## Proposal for Supplement 21 to UN Regulation No. 106 (Tyres for agricultural vehicles and their trailers)

### Submitted by the Working Party on Noise and Tyres\*

The text reproduced below was adopted by the Working Party on Noise and Tyres (GRBP) at its seventy-eighth session (ECE/TRANS/WP.29/GRBP/76, para. 19). It is based on ECE/TRANS/WP.29/GRBP/2023/9. It is submitted to the World Forum for Harmonization of Vehicle Regulations (WP.29) and to the Administrative Committee (AC.1) for consideration at their March 2024 sessions.

"Part C: Implement tyres

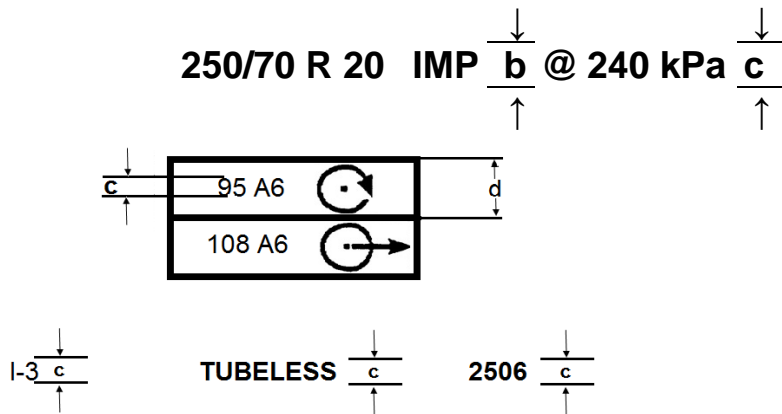
Annex 3, Part C, amend to read:

Example of the markings to be borne by types of tyres complying with this Regulation

These markings define an implement tyre:

- (a) Having a nominal section width of 250;
- (b) Having a nominal aspect ratio of 70;
- (c) Of radial-ply structure (R);
- (d) Having a nominal rim diameter of 508 mm, for which the code is 20;

- (e) Designed primarily for the equipment of implements, agricultural machinery or agricultural trailers (IMP);
- (f) Having load capacities of 690 kg corresponding to the load capacity index 95 shown in Annex 4 when used on driven axles (traction application), as identified by the appropriate symbol;
- (g) Having load capacities of 1,000 kg when used on non-driven axles (trailer application) corresponding to the load capacity index 108 shown in Annex 4, as identified by the appropriate symbol;
- (h) Both applications being classified in the nominal speed category symbol A6 (reference speed 30 km/h);
- (i) For fitting without an inner tube "tubeless";
- (j) Manufactured during the twenty-fifth week of the year 2006 (see paragraph 3.2. of the Regulation);
- (k) Requiring to be inflated to 240 kPa for measurements and tyre resistance to burst and, if applicable, load/speed test.
